# **2006 - 2009 Cadillac XLR XLR-V: Service Bulletin: Slips in Reverse or Third, Delayed Reverse or Drive Engagement**

## **#09-07-30-004J: Slips in Reverse or Third, Delayed Reverse or Drive Engagement, DTC P0776, P2715, P2723, Harsh 2-3 Shifts (Inspect 1-2-3-4 / 3-5-R Housing and Pump Seal Rings) - (Feb 25, 2014)**

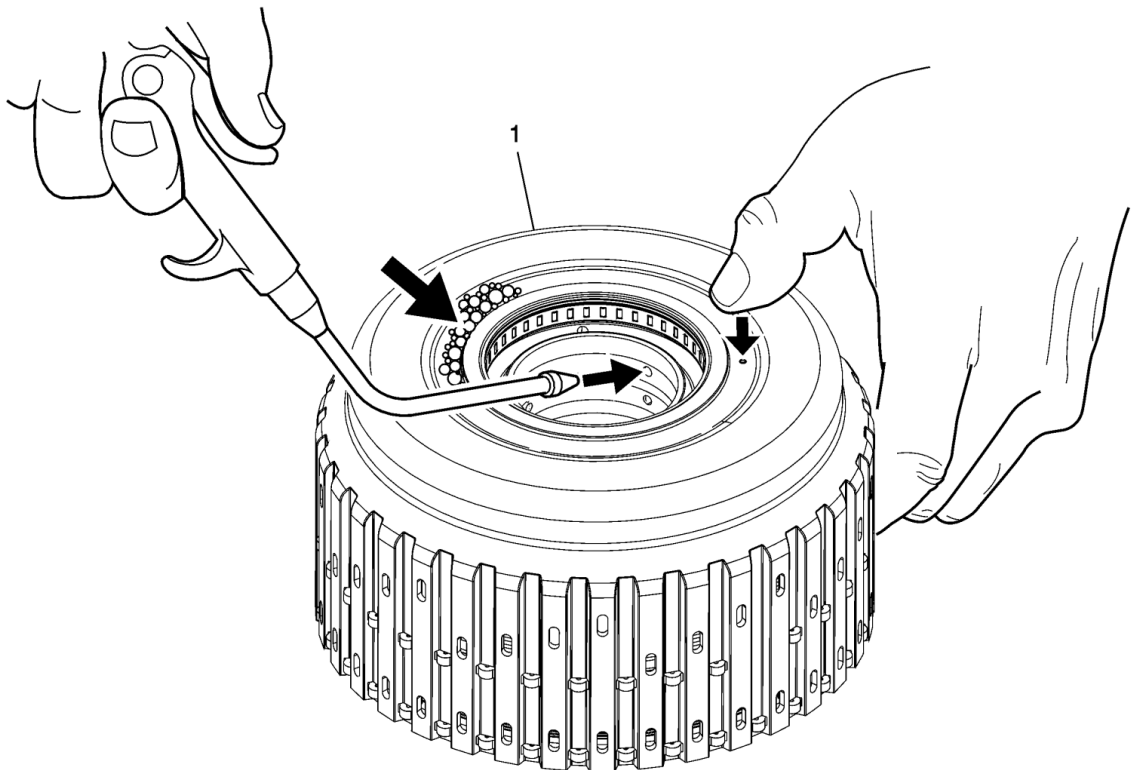
This condition may be caused by a cracked 1-2-3-4 / 3-5-R clutch housing.

**Important:** If a cracked housing is identified, it must be replaced. Complete, assembled 1-2-3-4 / 3-5-R clutch housings are now available for most applications. These clutch housings come complete with all pistons, seals, clutches, bearing and internal parts. No assembly of the clutch housing is required before it is installed. For applications without a complete, assembled 1-2-3-4 / 3-5-R clutch housing, individual parts must be ordered and the housing assembled in the

## **Housing Disassembled**

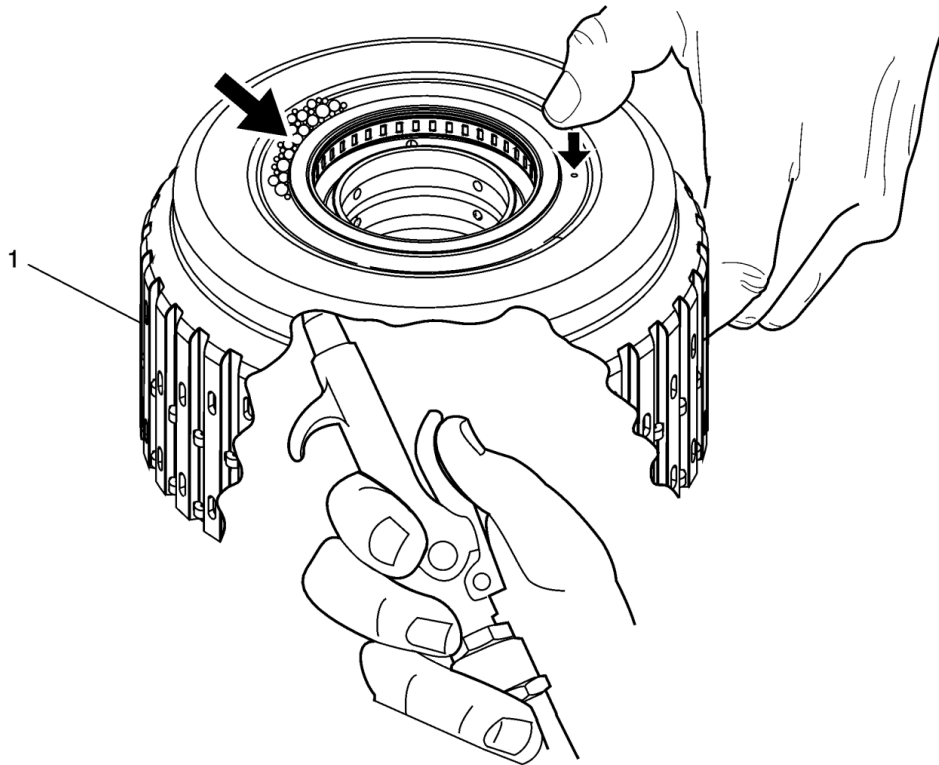
Inspect the 1-2-3-4 / 3-5-R clutch housing for a possible cracked weld.

1. Apply soap compound to weld area of the housing.
2. Hold your thumb over the air bleed passage.
3. Spray compressed air into the housing and inspect the weld area for bubbles.
4. If bubbles are detected, a new housing is required.

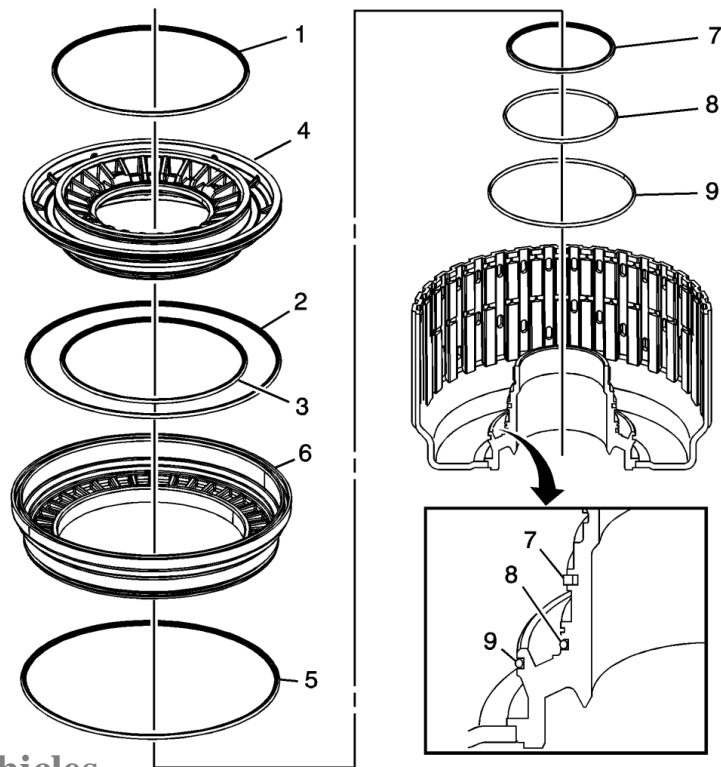
**Important:** The 6L80 transmission had a design change to the 1-2-3-4 piston, 1-2-3-4 piston housing and the 3-5-R piston for the 2008 model year. Installation of a 2008, 6L80 complete housing assembly into a 2007 or older 6L80 may result in a 2-3 shift flare or 3-5-R clutch distress.

**Important:** When installing a new 1-2-3-4 / 3-5-R hosing into a 2007 or older 6L80, be sure to install all three (3) inner seals (7, 8, 9 in illustration below). Failure to install these seals can result in no reverse, no forward or distressed clutches.

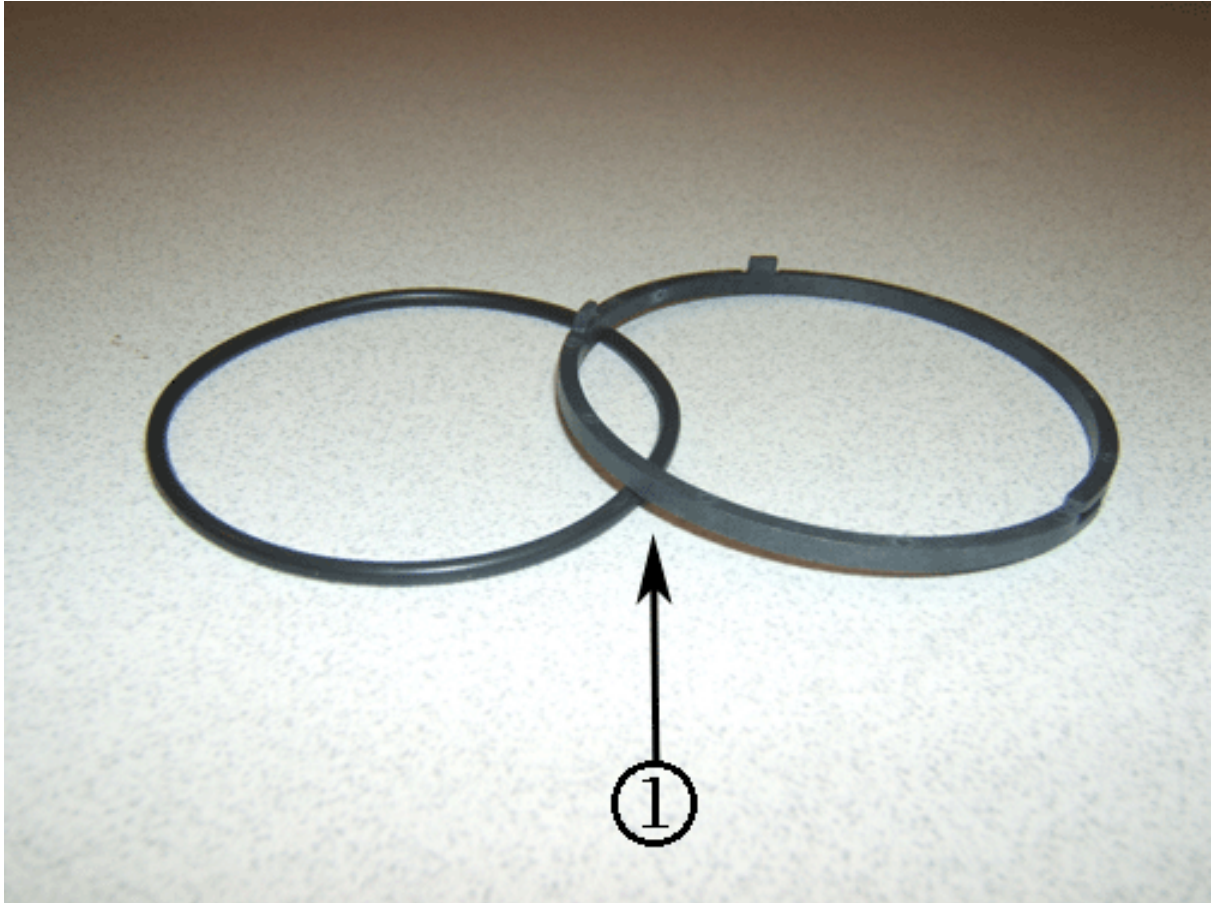
A harsh 2-3 shift condition may be caused by leaking 1-2-3-4 and 3-5-R clutch fluid seal rings (1) on the transmission fluid pump cover assembly.

Inspect the fluid seal rings. Transmissions in 2006, 2007, 2008 and early build 2009 models used a 1- piece design seal ring in production. Starting December 2008, a 2-piece seal ring design was implemented. The 1-piece seal ring design may cause a harsh 2-3 shift due to leakage. This is typically a low mileage issue. If the seal rings are a 1-piece design they should be replaced with new 1-piece design seal rings. It is not necessary to replace the pump cover.

**Notice:** The clutch fluid seal rings must be installed in a specific way. Failure to install new clutch fluid seal rings in the proper orientation may cause a repeat harsh 2-3 shift. Refer to 1-2-3-4 and 3-5 Reverse Clutch Fluid Seal Ring Installation (6L80/90) in SI for correct installation.
